SUBMITTAL IDENTIFICATION SHEET

WEBSTER UNIVERSITY ISB
PROJECT NAME

084423-20
CONTRACTOR / CM SUBMITTAL NO.

RE: Extruded silicone coping gasket

EST. AREA		DESCRIPTION	DR. BY	DATE 08-01-16
	EST. WT. FT.		COPING GASKET	MAT. SILICONE	SCALE FULL
	EST. PERIM		FINISH:	FILE	DIE NO.
	FACTOR			DWG#	
	CLASS				
TYPICAL UNMARKED WALL .060	CIRCLE SIZE	4.0	CUSTOMER NGG		PART NO. NONE
UNLESS NOTED DIM'S ARE P.I.	REVISION	0

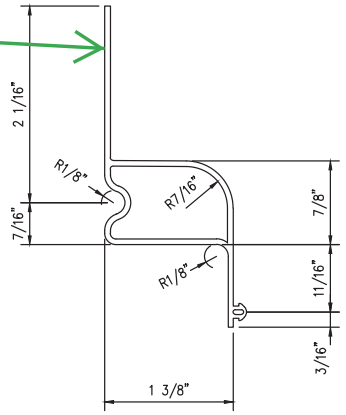
PLEASE SUBMIT MEANS OF ATTACHMENT. (THE DESIGN TEAM RECOMMENDS USE OF A SST TERM BAR SET IN A FULL BED OF SEALANT) AND DETAIL FOR HOW TWO SECTIONS WILL BE CONNECTED/SEALED FOR A WATER AND WEATHERTIGHT CONNECTION.

GASKET COLOR: BLACK

CONFORMANCE WITH DEFLECTION/ELONGATION CRITERIA SHALL BE REVIEWED/CONFIRMED BY CURTAIN WALL MANUFACTURER
